**TOWN OF NEWBURGH
PLANNING BOARD
TECHNICAL REVIEW COMMENTS**

PROJECT: PROPOSED PET HOTEL AND DAYCARE (MIDDLEHOPE VET)
PROJECT NO.: 12-19
PROJECT LOCATION: SECTION 9, BLOCK 3, LOT 22.2 & 23
PROJECT REPRESENTATIVE: T.M. DEPUY ENGINEERING & LAND SURVEYING, P.C.
REVIEW DATE: 9 OCTOBER 2015
MEETING DATE: 15 OCTOBER 2015

SITE PLAN
SCALE: 1" = 20'

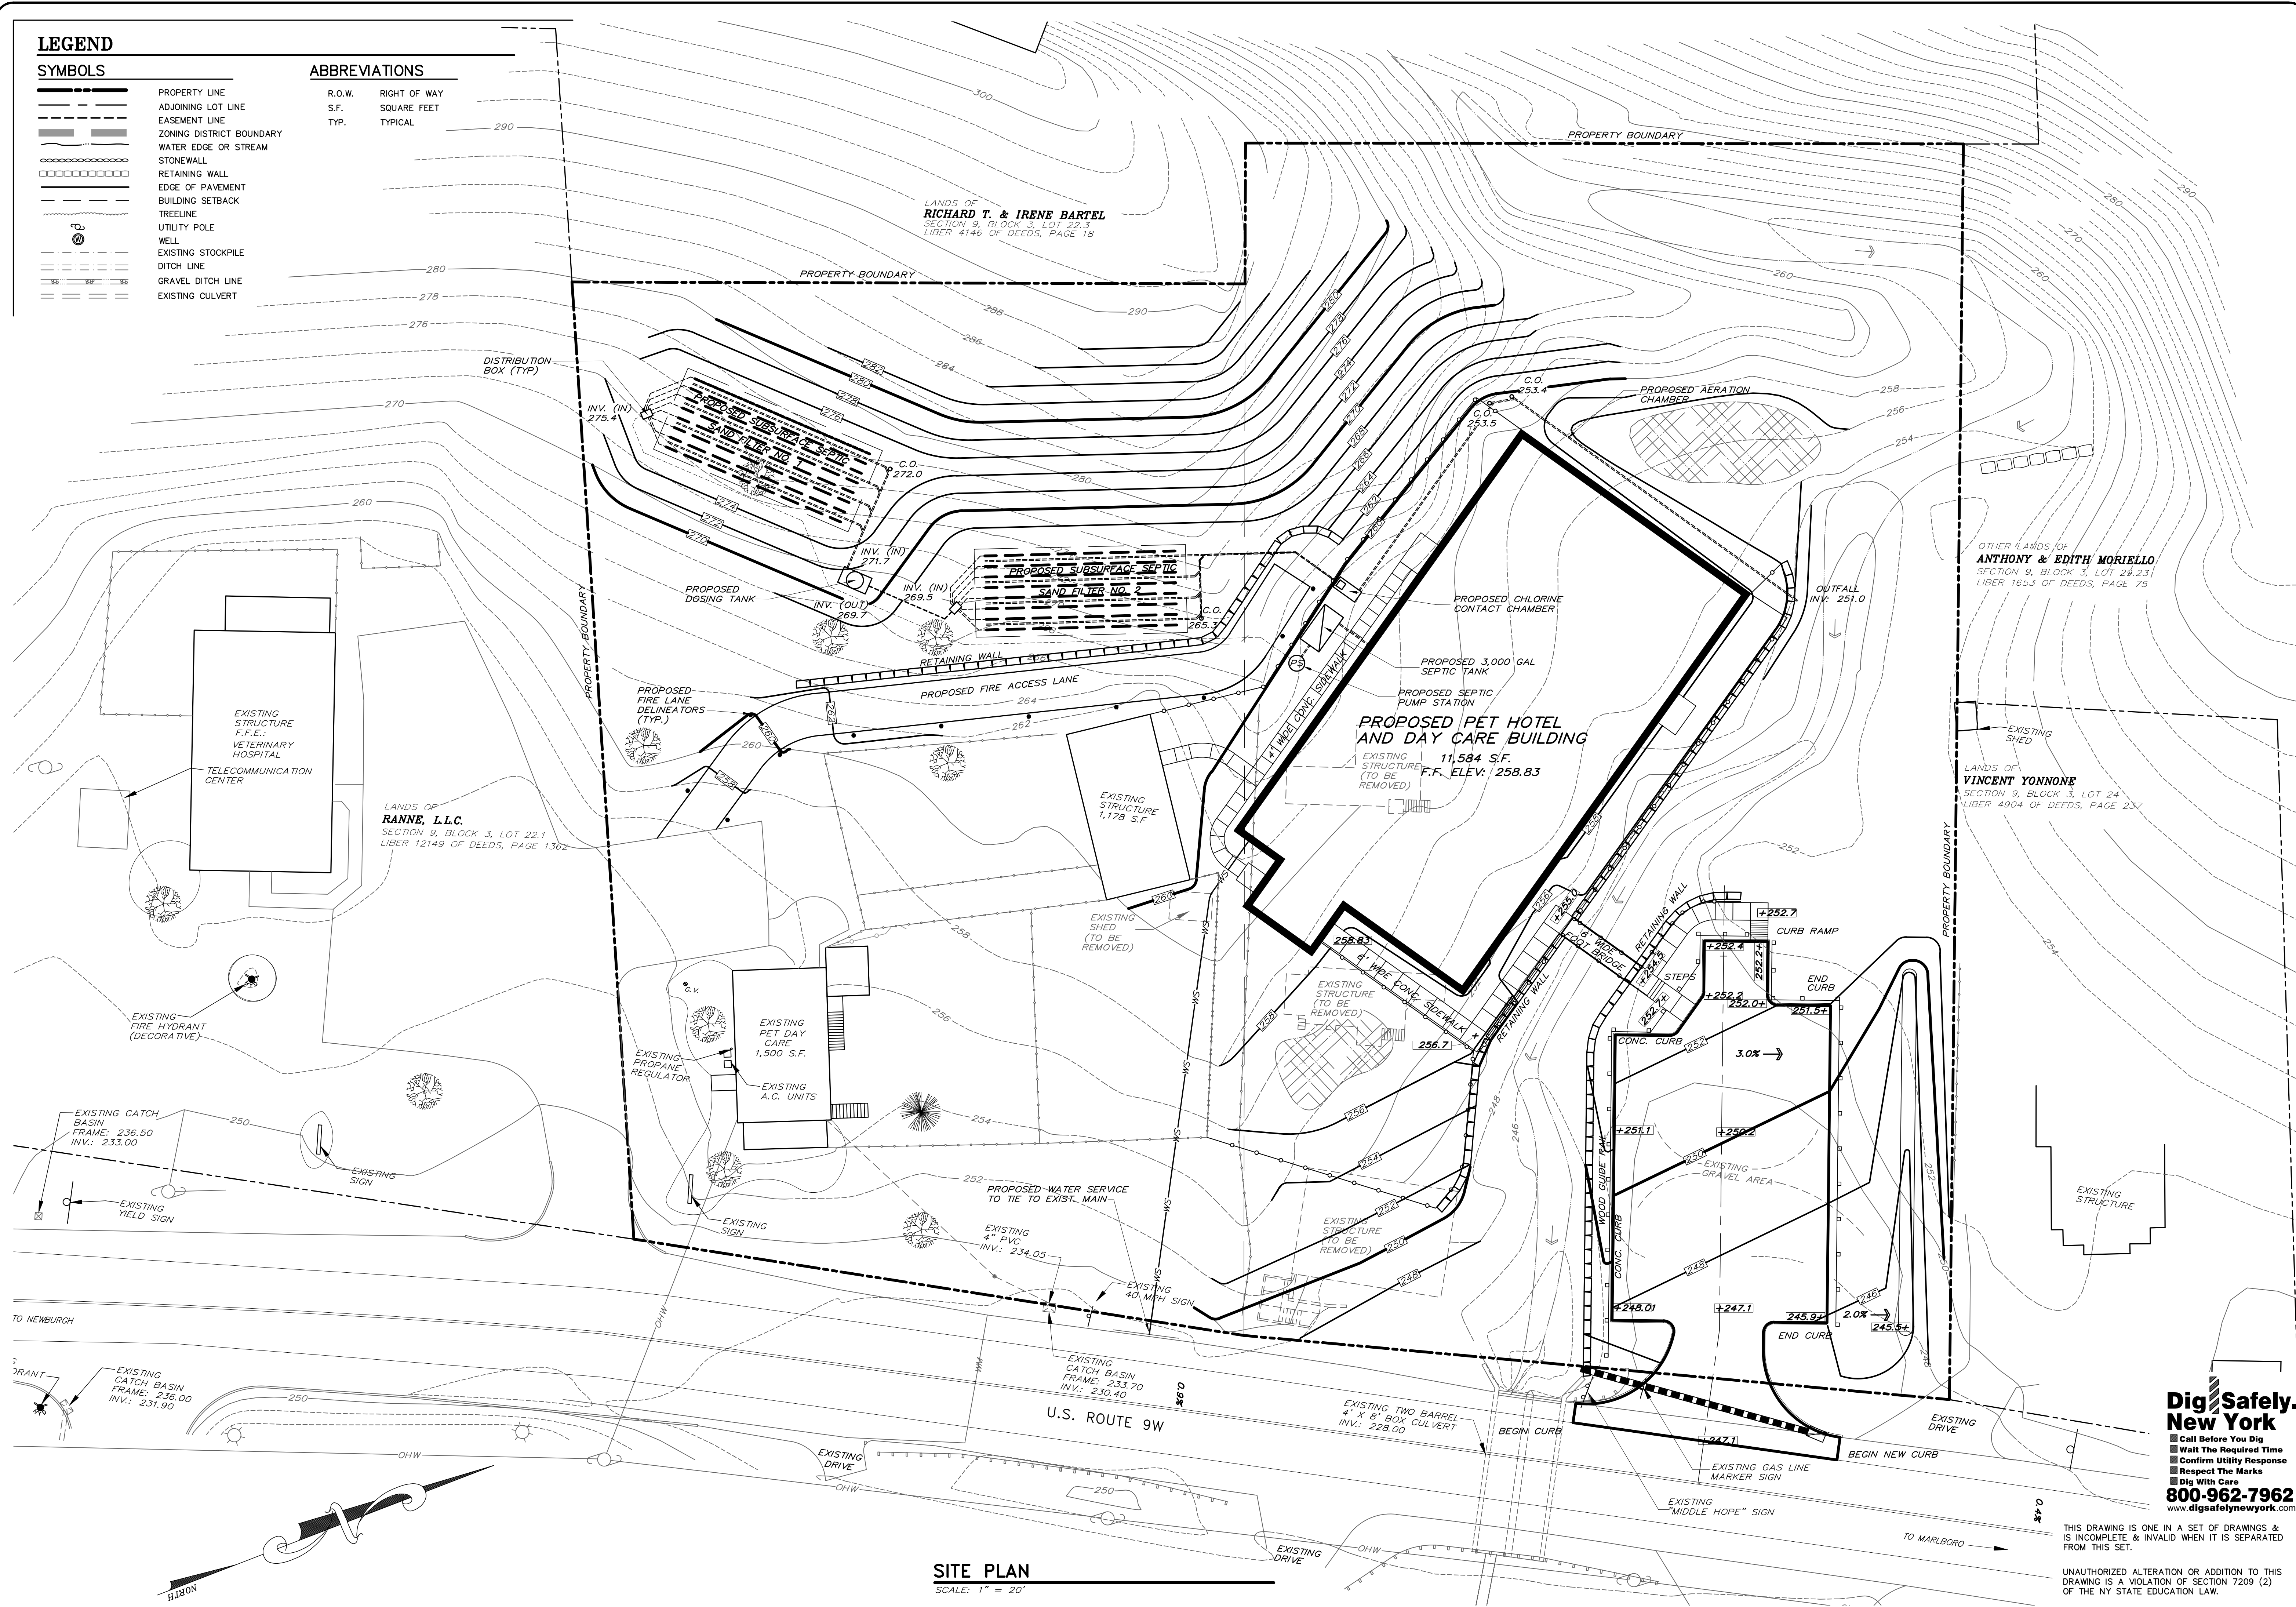
4. Project involves the consolidation of two existing lots.
5. Limits of disturbance should be depicted on the plans and calculated to determine if greater than 1 acre disturbance is proposed.

6. Bulk table should be added to the plan sheet to determine compliance with existing structures and setbacks. It is unclear if the existing Pet Daycare Facility structure complies with Zoning Bulk Table Requirements.

8. Town of Newburgh water connection details and notes must be provided on the plans.

9. Building will be required to be sprinklered. Town of Newburgh Fire and Potable water is terminated if sprinkler line is shut off.
10. Parking calculations should be added to plans.
11. Details of retaining walls structures in excess of 4 feet must be added to the plans along with a note identifying that all retaining walls in excess of 4 feet must receive a Building Permit upon submission of stamped design plans.
12. Soil erosion and sediment control details should be added to plan sheet.
